LAKE COUNTRY LUTHERAN

PRELIMINARY DEVELOPMENT PLANS
CAMPUS DRIVE
VILLAGE OF HARTLAND, WISCONSIN

Village STAFF Review Comments Dated 7/14/2020

SHEET
T1

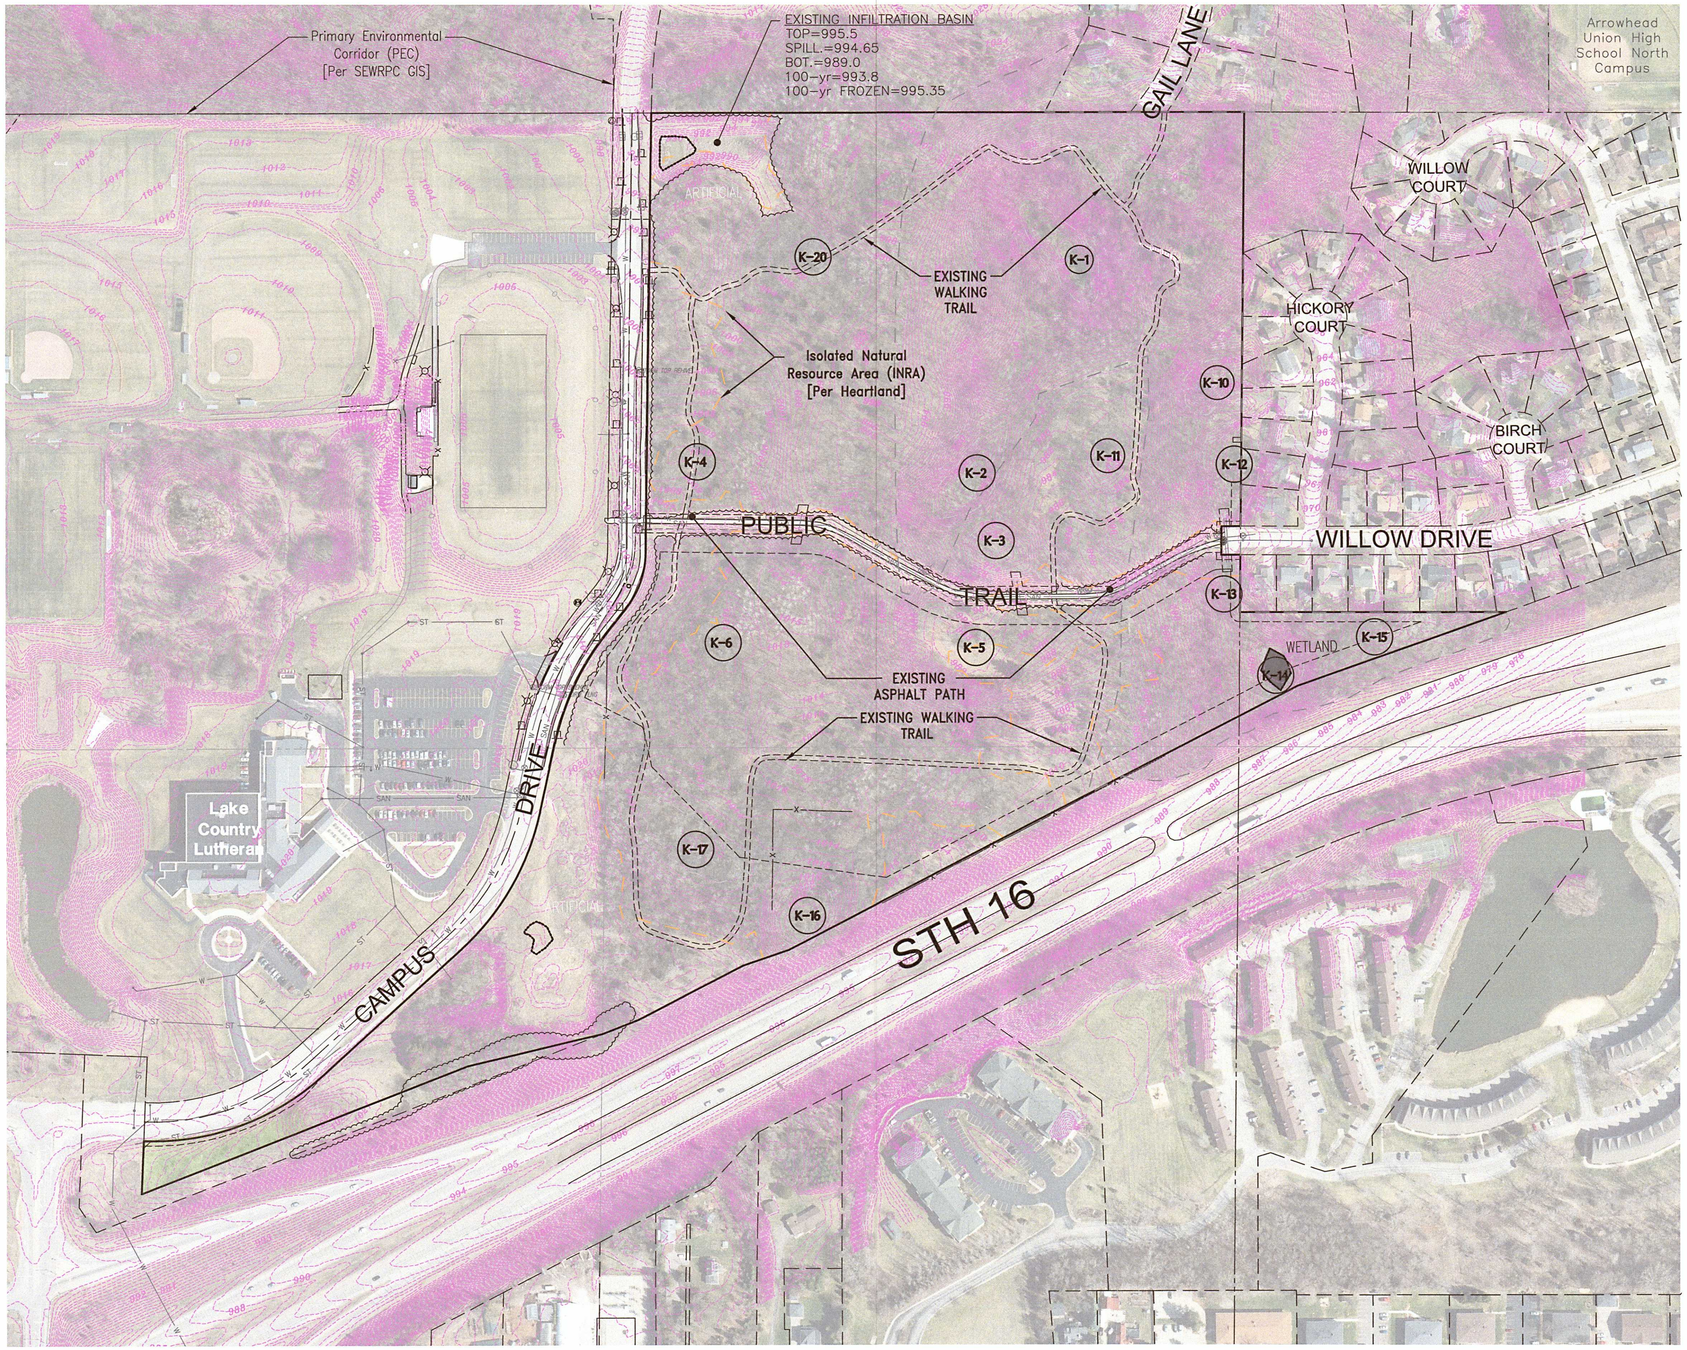
ADD Pavement Marking/Signing (Show Existing Conditions @ Campus Drive Connections)
ADD Landscape sheet

SHEET
C0.20

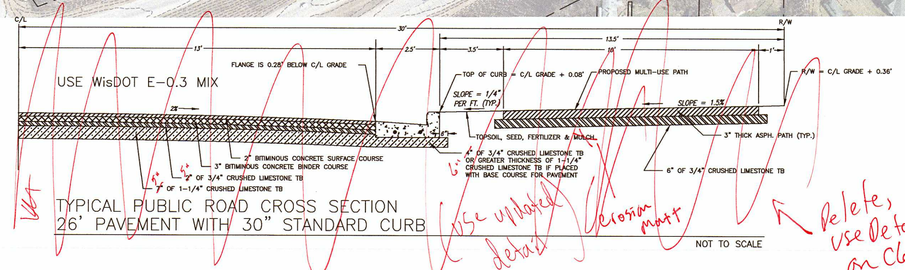
Use updated details

Delete, use detail on C601

move to detail sheet

SHEET
C1.04

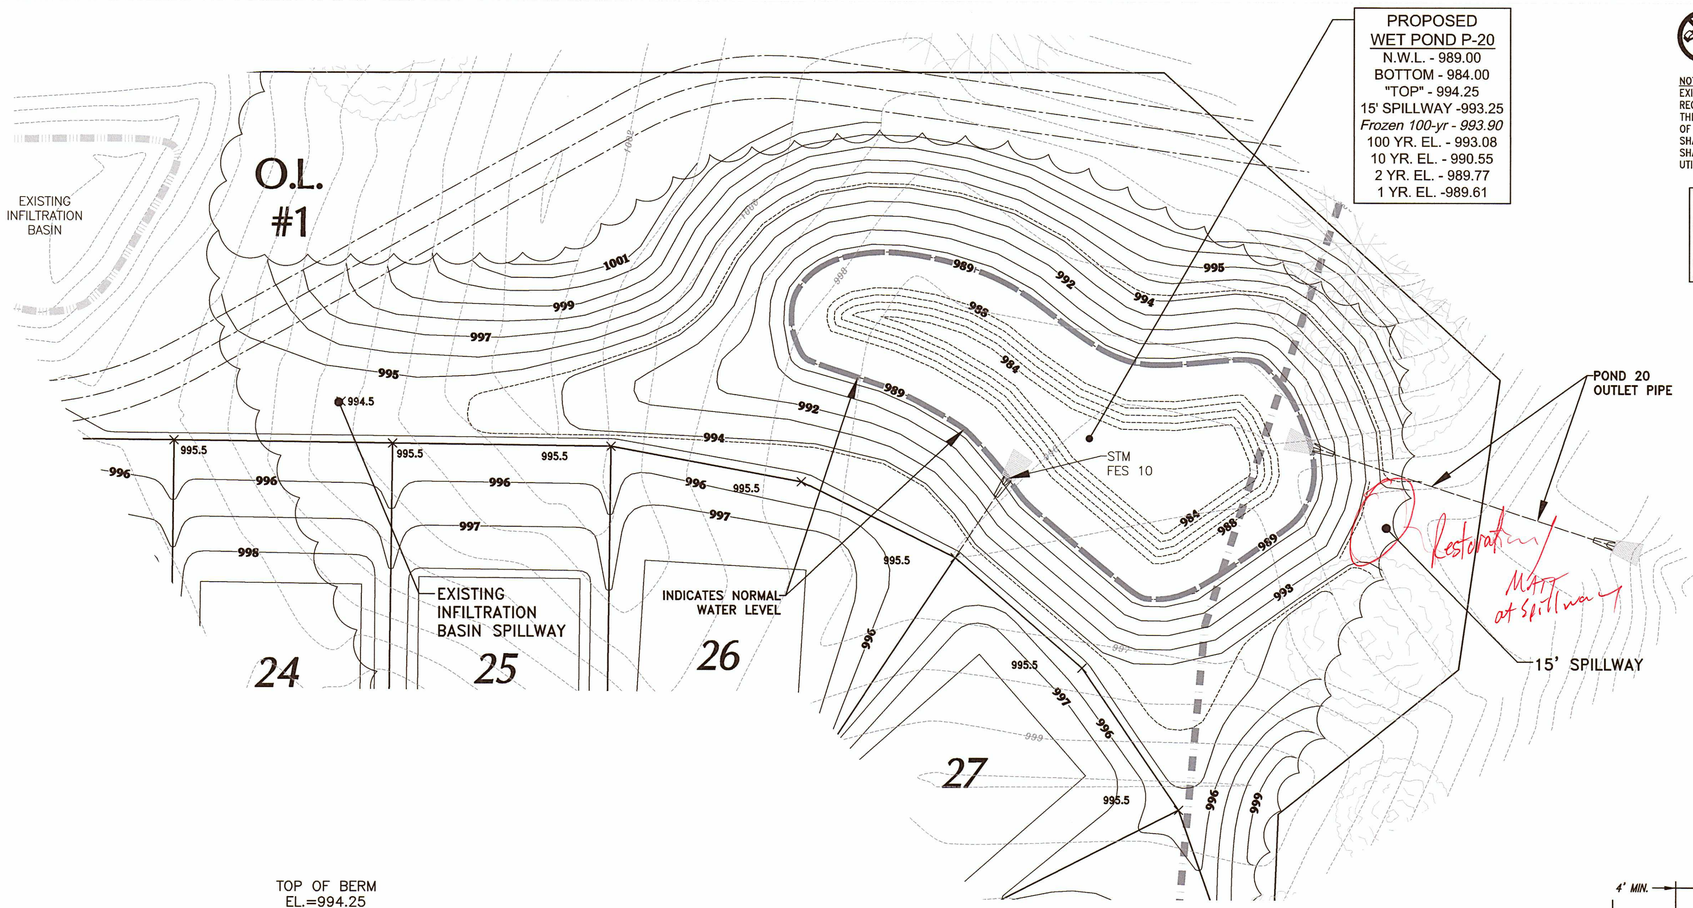
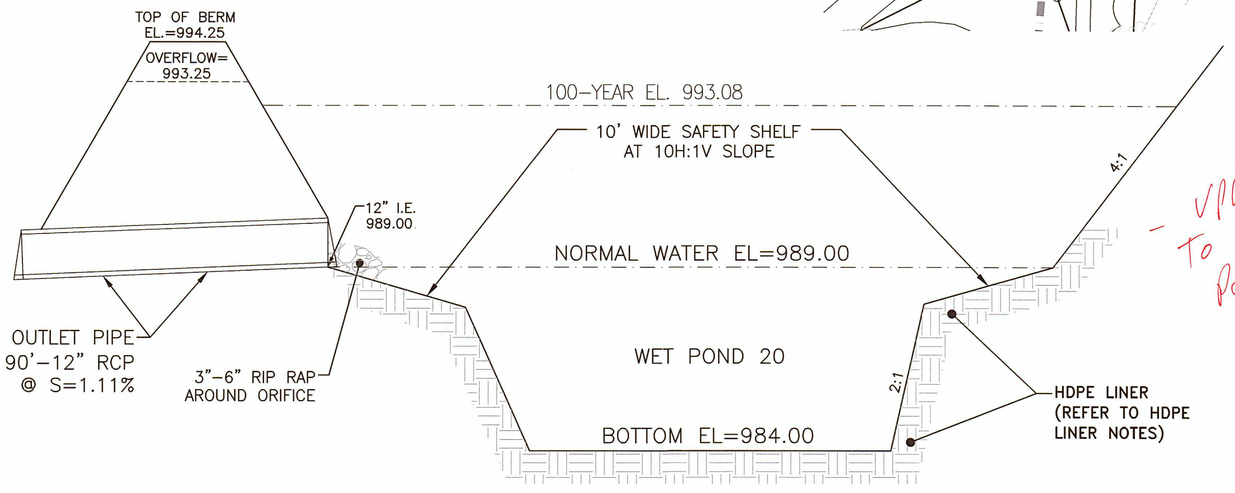
- Change to Basin - Update
- What type/size of Inlet Grates?
- Why is this 3'? → 11' F-3'
  - What type Classification
  - Where is Row Line
  - Who
- Min Stall Size Should Be 180 Sq. Ft.
  - Use 20' length from Back Curb To End Stall (Typ. for all parking areas)

SHEET
C3.01

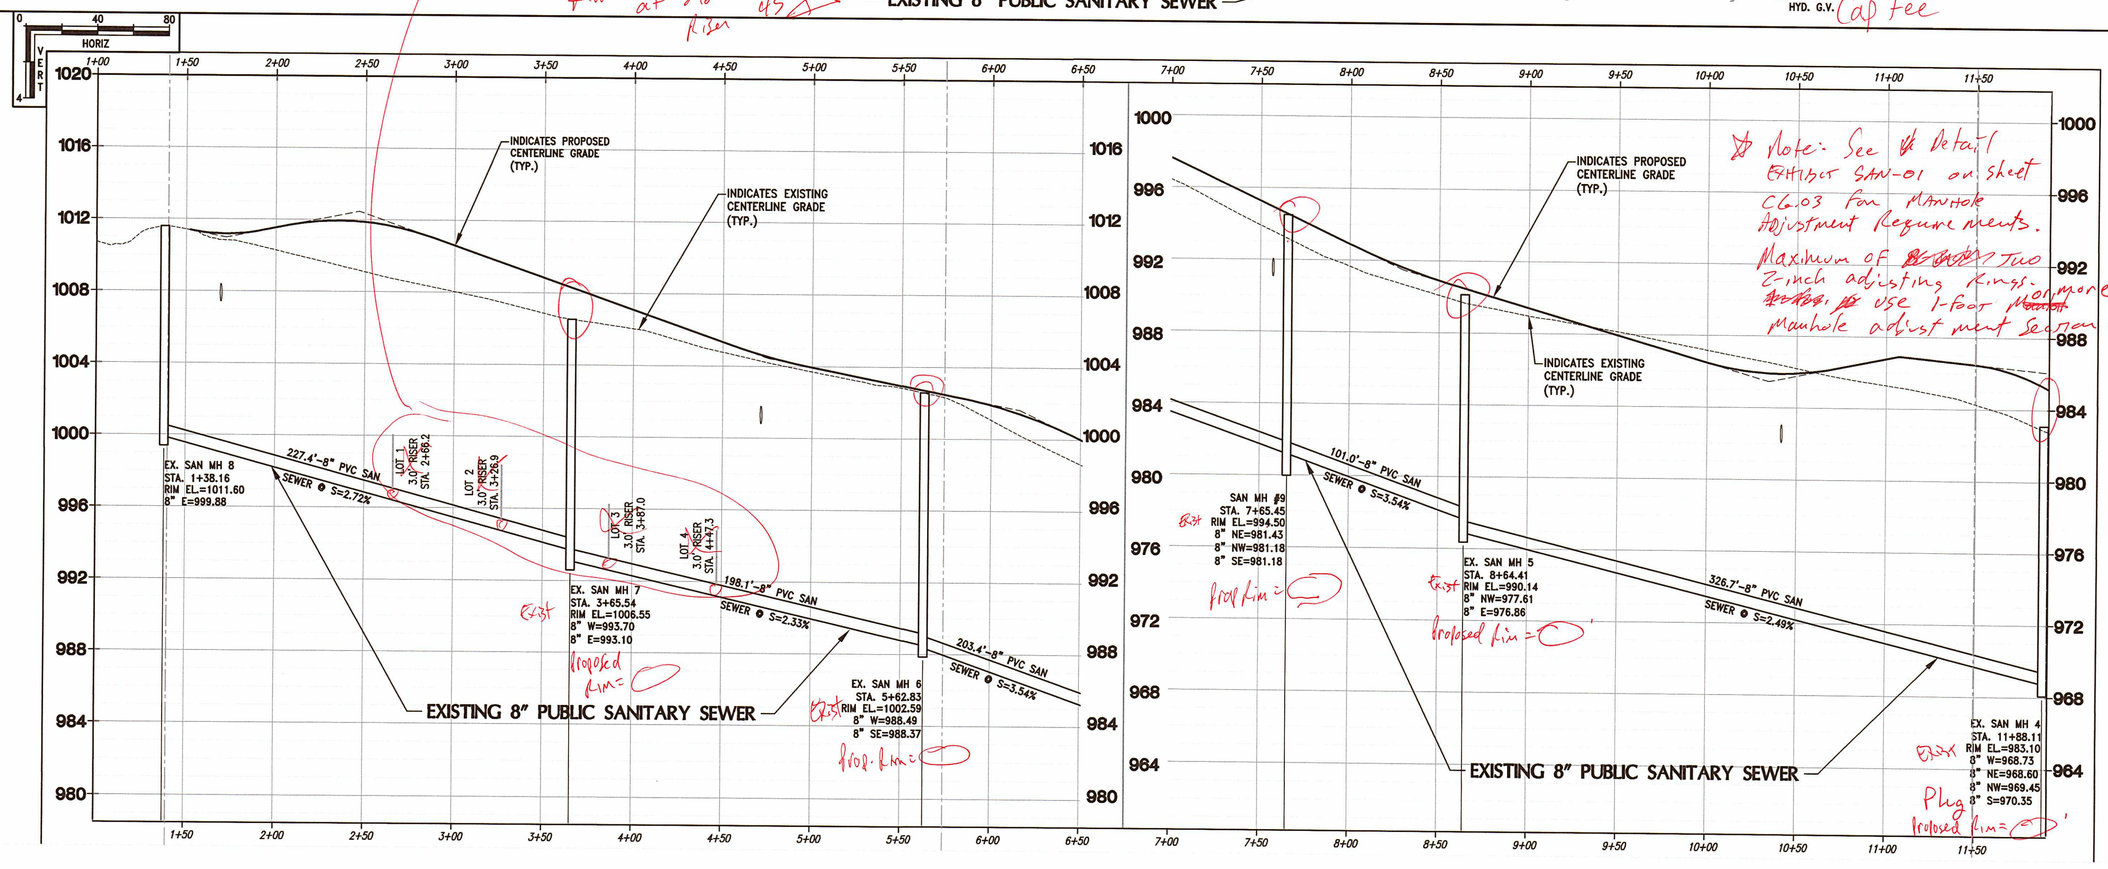
Review Layout w/ Pelkman ☆ Contractor shall bypass pump Sewer during Connections. ☆ No Risers. use Cut in wye w/fernco & Lateral at 2% or modified 45° Riser

SHEET
C4.05

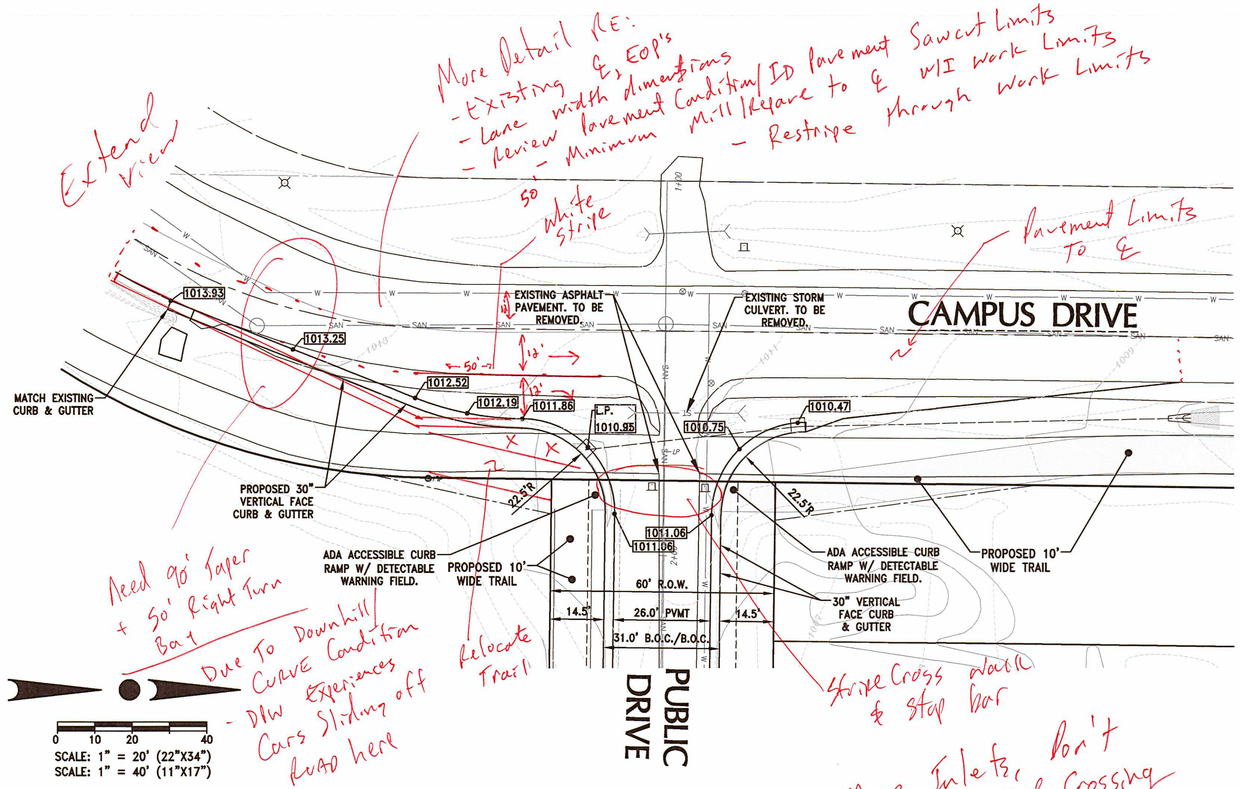
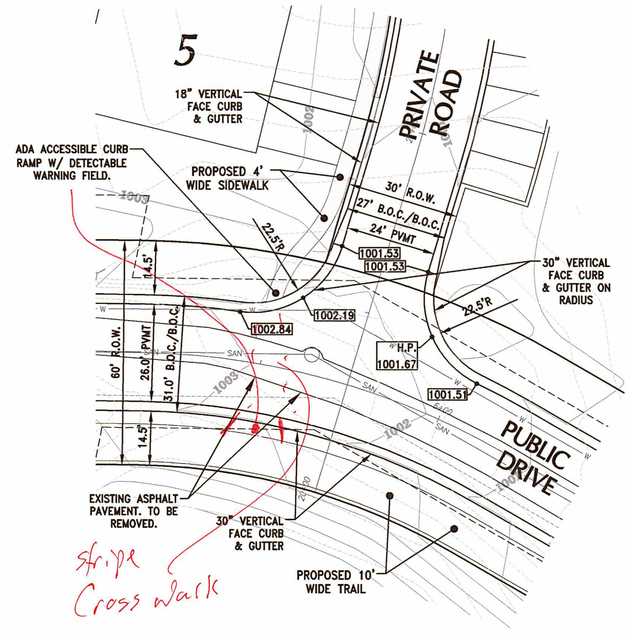
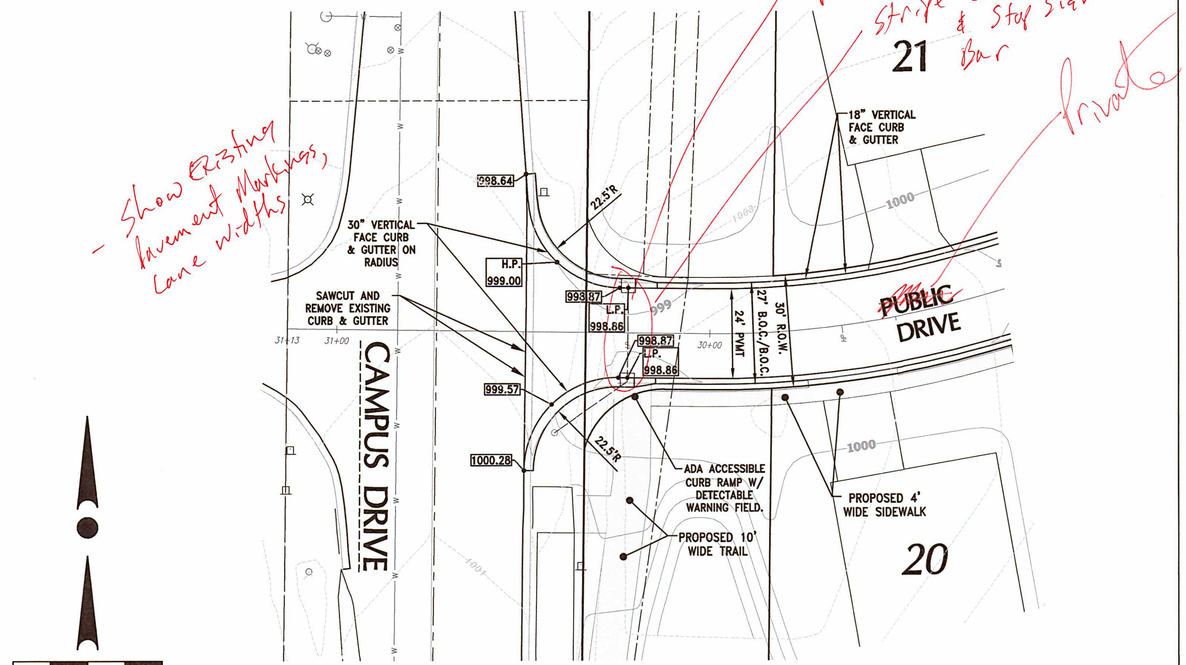
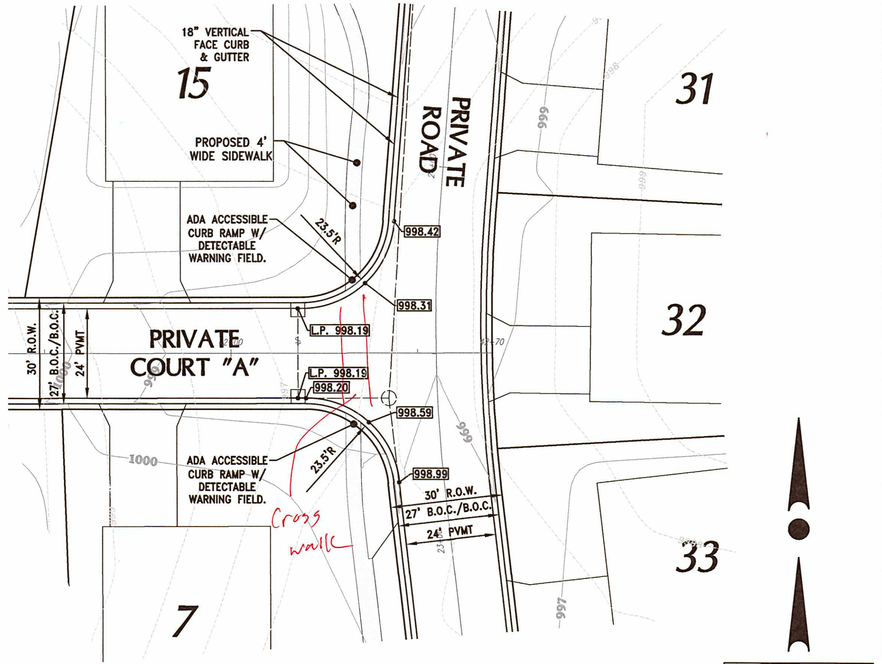
Concrete Cut off wall, bolt AEW TO, Show detail Ekk

SWING GATE BOLLARD DETAIL

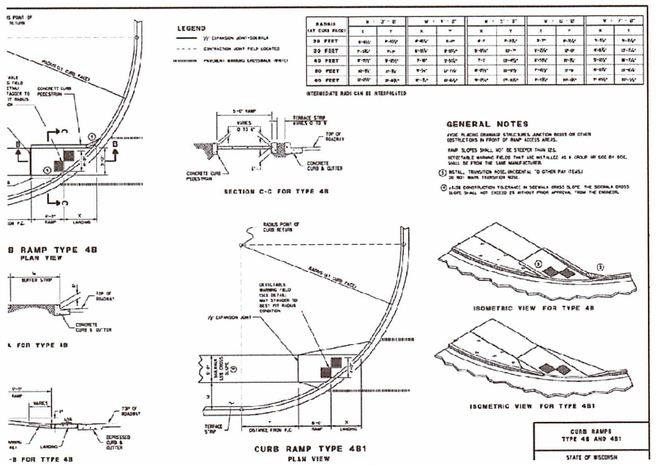
Use RiverWalk Gate Spec provide Bollards Village to do After

WATER MAIN MONITORING METER VAULT DETAIL

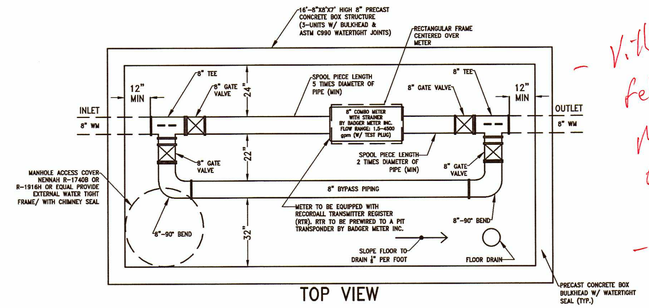
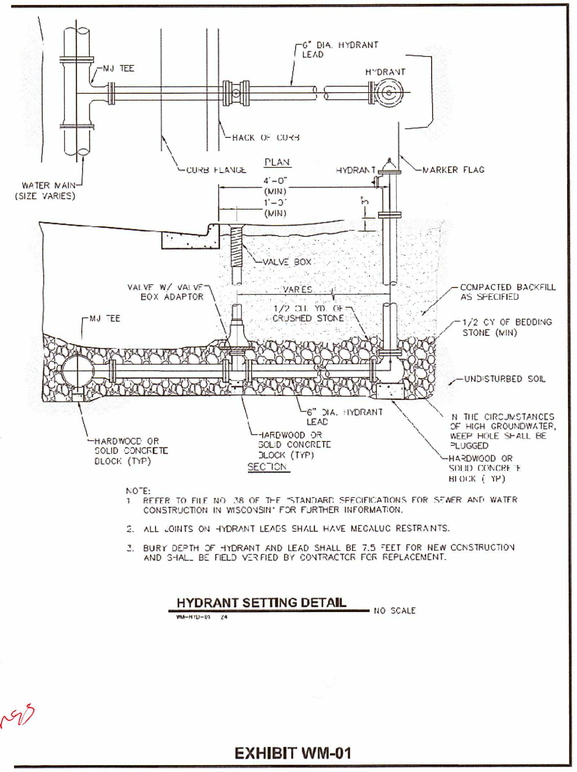
- Village, have Felker getting more detail from Midwest Meter.

★ ~~Shop~~ Shop Drawing to be Reviewed/Approved by Village prior to ORDERING MATERIALS.

CATCH BASIN DETAIL NO SCALE

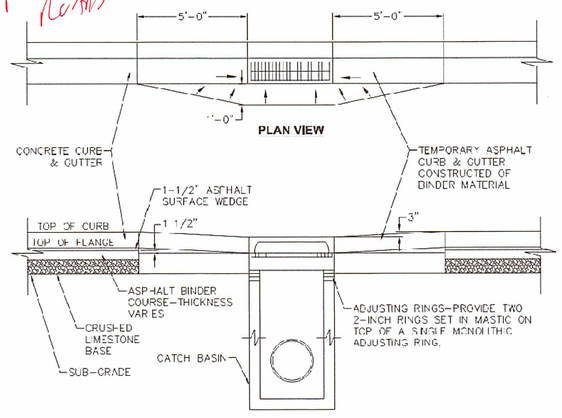
- What type of Castings being used in private roads?

RISER DETAIL "TYPE C" * FLEXIBLE RISER TO RIGID MAIN (ALTERNATIVE A)	
NOT TO SCALE JULY 1987	FILE NO. 10C

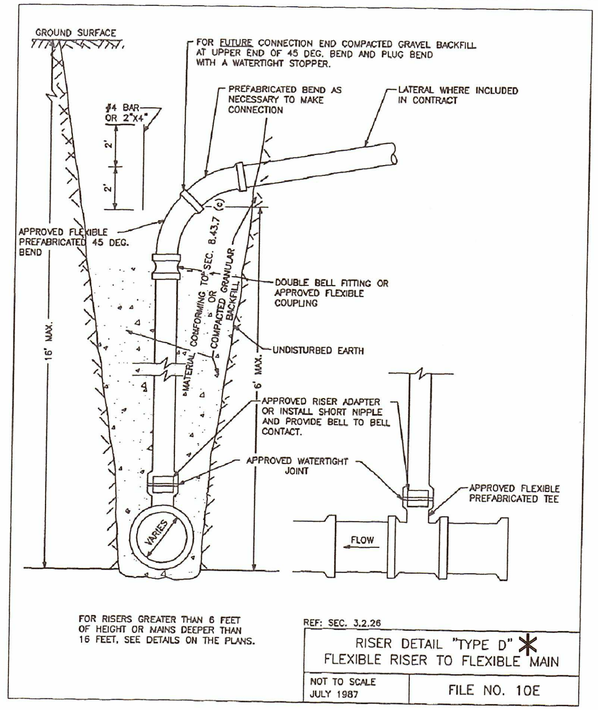
Specify 1 Riser For Detail
